Model: Antares-PJ1 cw	Date: 17-May-12	No.: RY020001c
-----------------------	-----------------	----------------

Subject: Firmware Release Note: Main		Prepared by: S. Ishizu	
From: NA Support Sect, Solution Support Dept.			
Classification:	<input type="checkbox"/> Troubleshooting <input type="checkbox"/> Mechanical <input type="checkbox"/> Paper path <input type="checkbox"/> Product Safety	<input type="checkbox"/> Part information <input type="checkbox"/> Electrical <input type="checkbox"/> Transmit/receive <input checked="" type="checkbox"/> Other (Firmware)	<input type="checkbox"/> Action required <input type="checkbox"/> Service manual revision <input type="checkbox"/> Retrofit information <input checked="" type="checkbox"/> Tier 2

Model: Antares-PJ1cs/cx/cw		Date: 20-Aug-12	No.: RY020005
Subject: PartsCatalog Correction		Prepared by: Shingo Ishizu	
From: 2nd Tech Service Sect., MFP/P Tech Service Dept.			
Classification:	<input type="checkbox"/> Troubleshooting <input type="checkbox"/> Mechanical <input type="checkbox"/> Paper path <input type="checkbox"/> Product Safety	<input checked="" type="checkbox"/> Part information <input type="checkbox"/> Electrical <input type="check

No.: RY020005

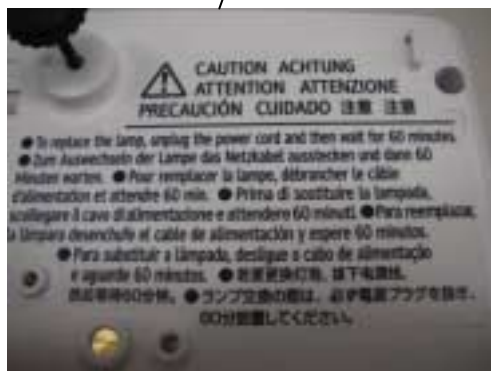
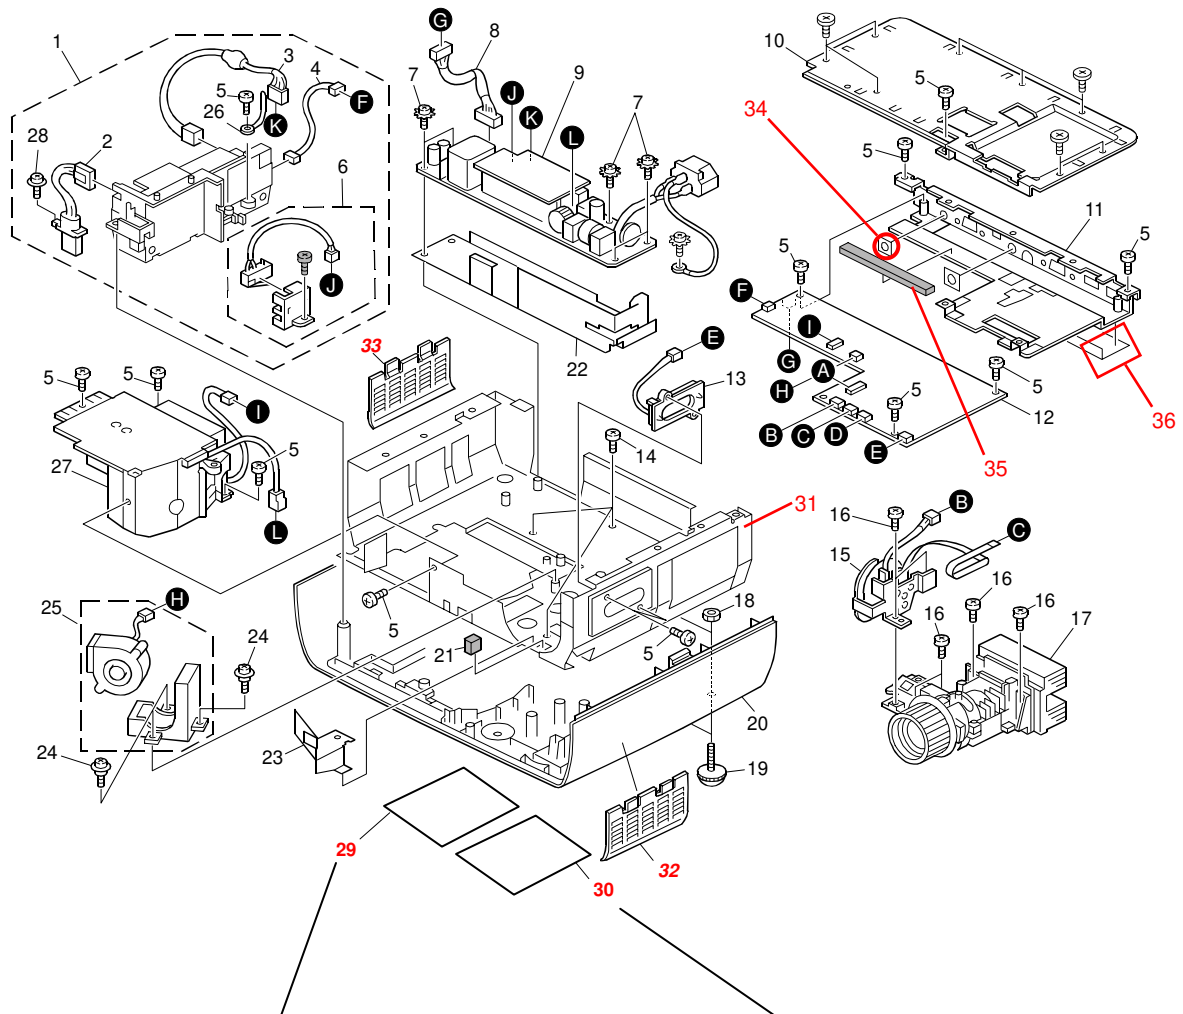
Change: The parts highlighted in **bold** were newly registered as service parts.

Reason: To improve serviceability.

No.: RY020007

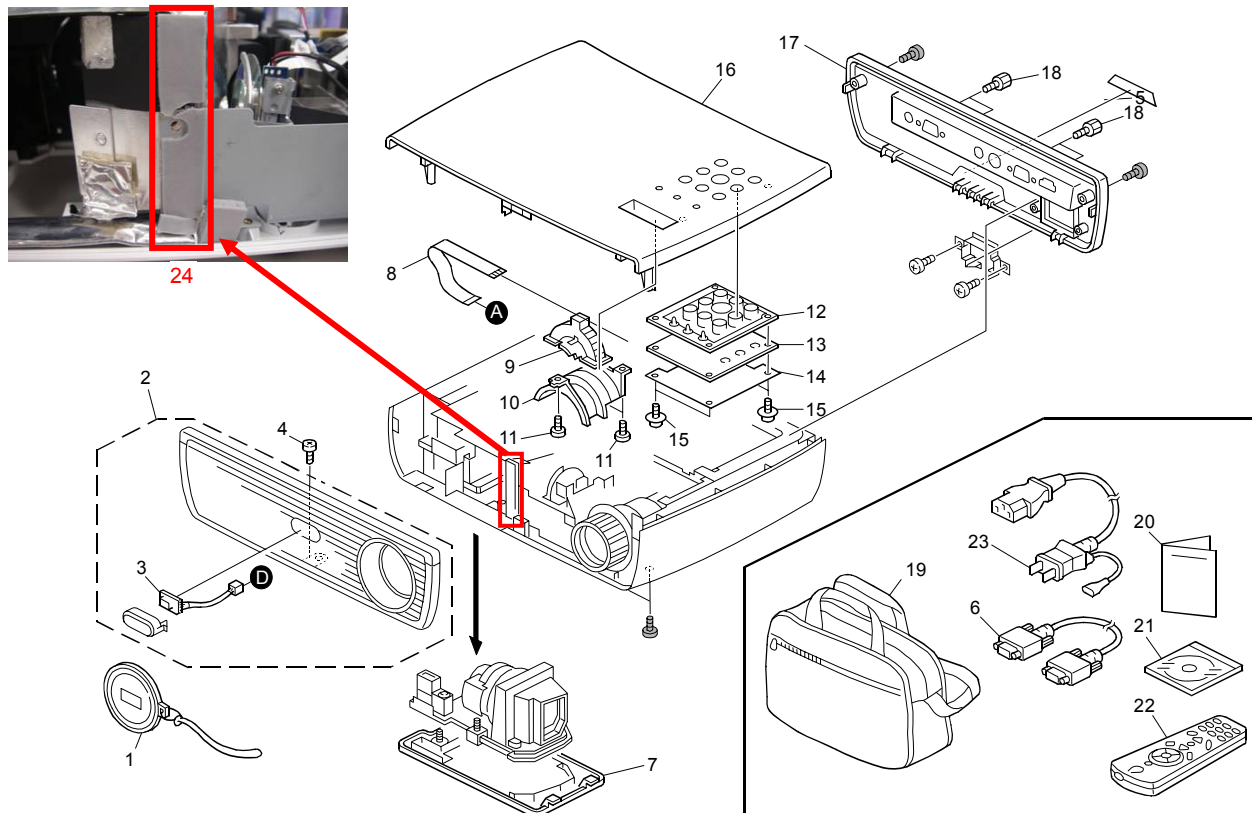
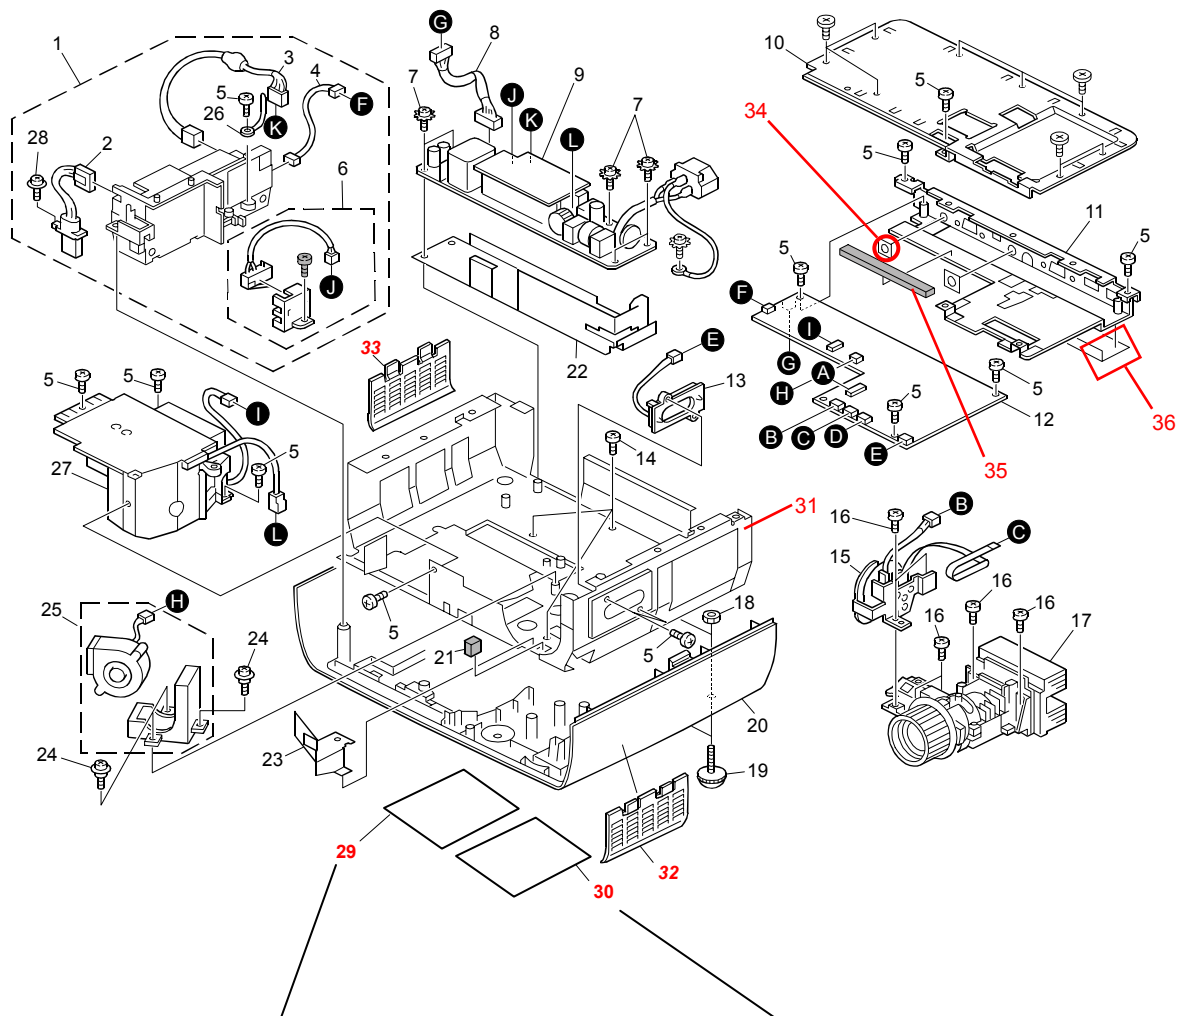
Change/ Reason: The parts highlighted in **bold** were newly registered as service parts.

No.: RY020008

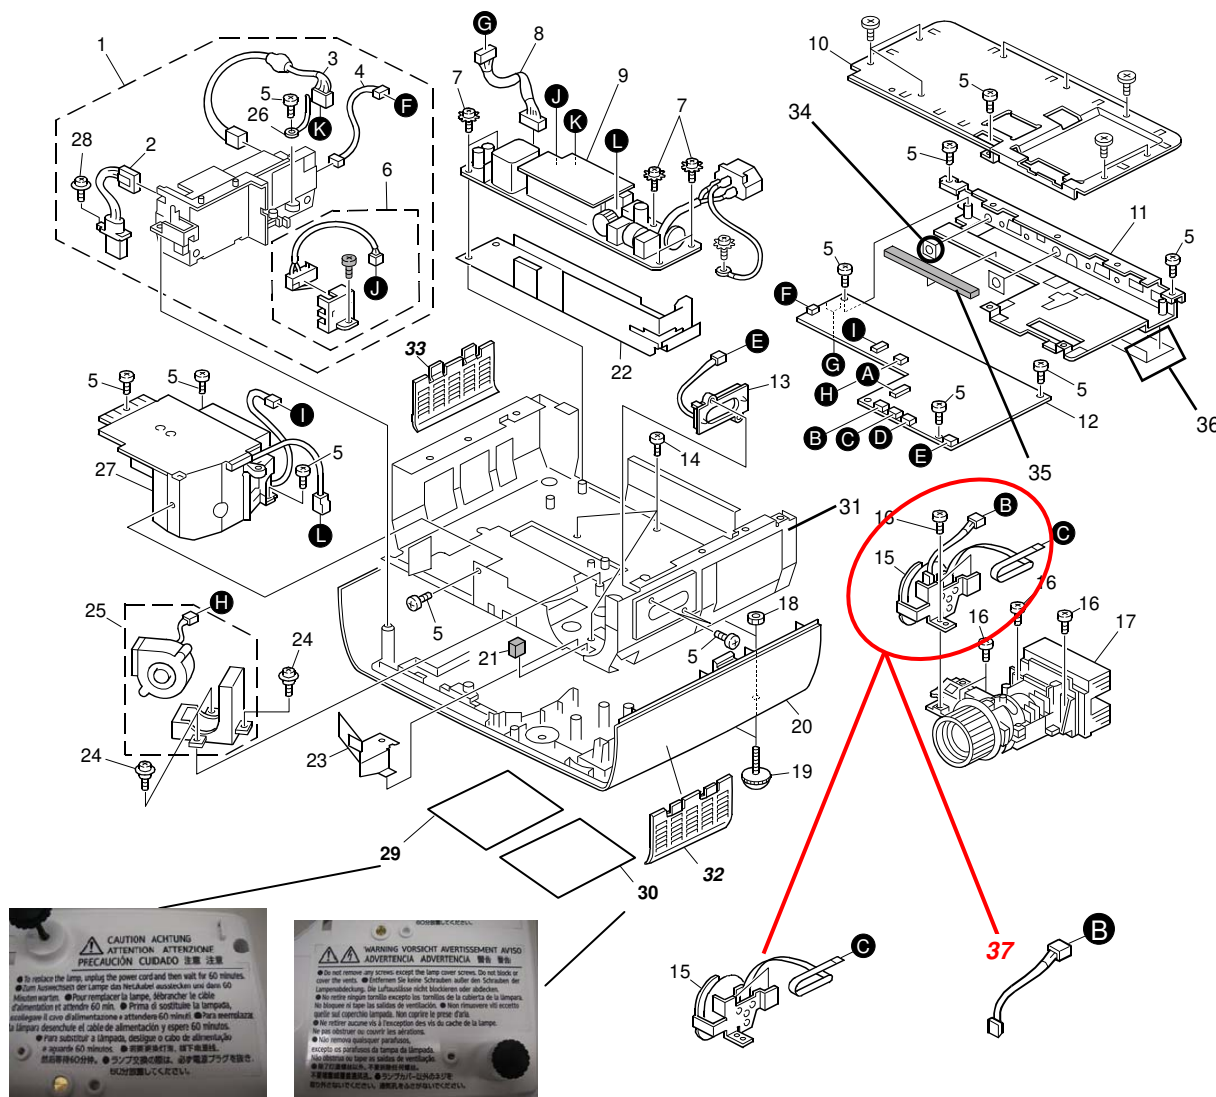
Change/ Reason: The parts highlighted in **bold** were newly registered as service parts.

No.: RY020010

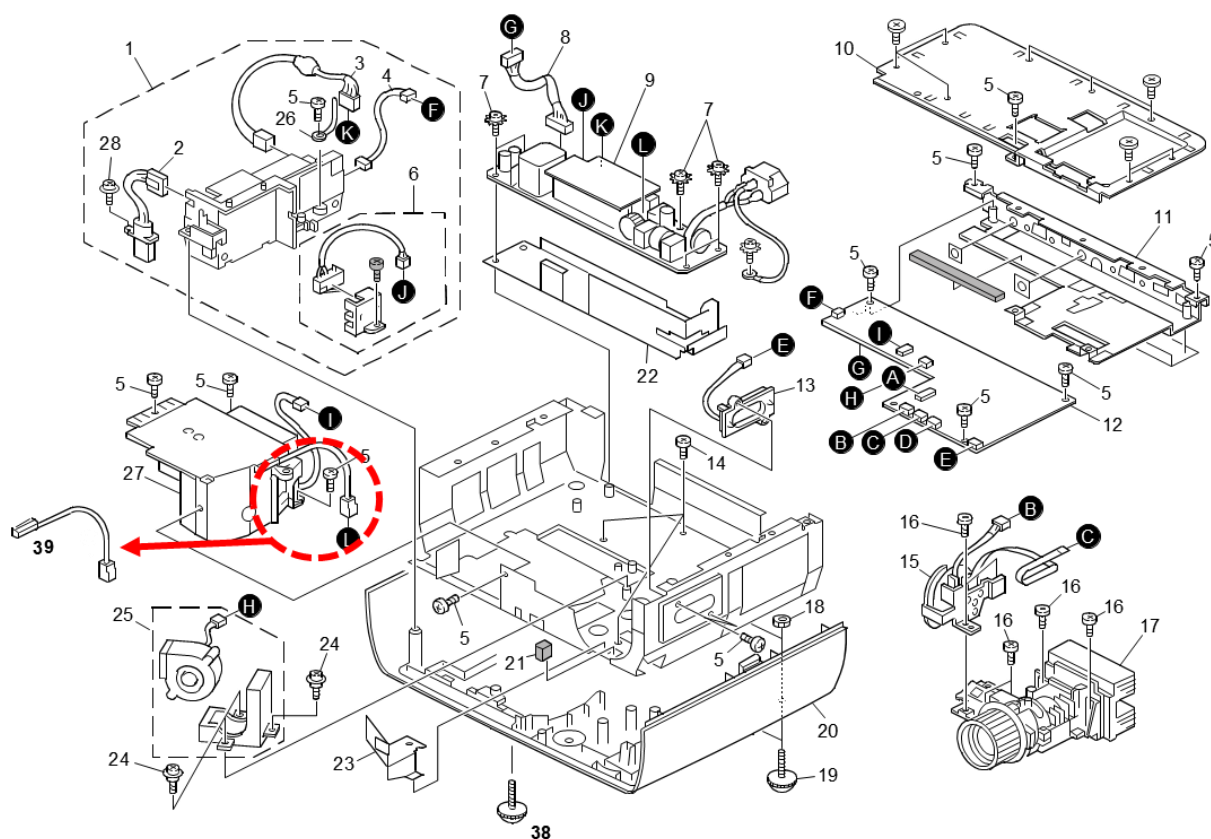
Change: The parts were newly added.

Old part number	New part number	Description	Q'ty	Int	Page	Index	Note
-	Y0201062	Rubber foot front	1	-	3	38	
-	Y0202068	Thermo fuse	1	-	3	39
